# VAUGHAN Staff Report Summary

File: A099/21

57 Romeo Cr Woodbridge Address:

## Minor Variance Application

# SITE PLAN & BUILDING STATISTICS Lot 42 REG. PLAN 65M-2266 CITY of VAUGHAN

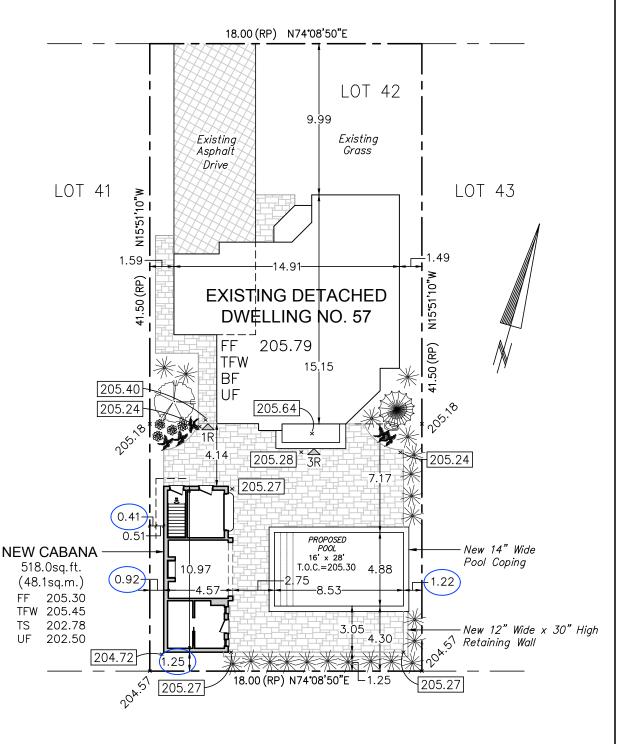
The Owner is proposing to construct a cabana and pool in the rear yard with the abovenoted variances. Variances 1, 2, and 3 for the proposed cabana are considered to be minor in nature. The cabana remains within the by-law requirements for maximum height and floor area and is at a distance from the rear and interior side yard that allows for appropriate drainage. The Development Planning Department does not object to Variance 4 as the Owner is proposing soft landscaping along the edge minimizing drainage impacts associated with an increase in hard landscaping.

The Development Engineering (DE) Department has also reviewed the application and have no concern with the reduction in rear yard soft landscaping, subject to the condition that the Owner demonstrate appropriate Low Impact Development (LID) measures to the satisfaction of DE to address the reduced soft landscaping coverage in the rear yard in order to mitigate potential impacts on the municipal storm water system. The Development Planning Department considers Variance 5 for the minimum interior side yard setback of 1.22 m to the pool minor in nature.

- 2. The owner/applicant shall demonstrate appropriate LID (Low-impact Development) measures to the satisfaction of DE to address the reduced soft landscaping coverage in the rear yard from 60% to 33.83% in order to mitigate potential impacts on the municipal storm water system.
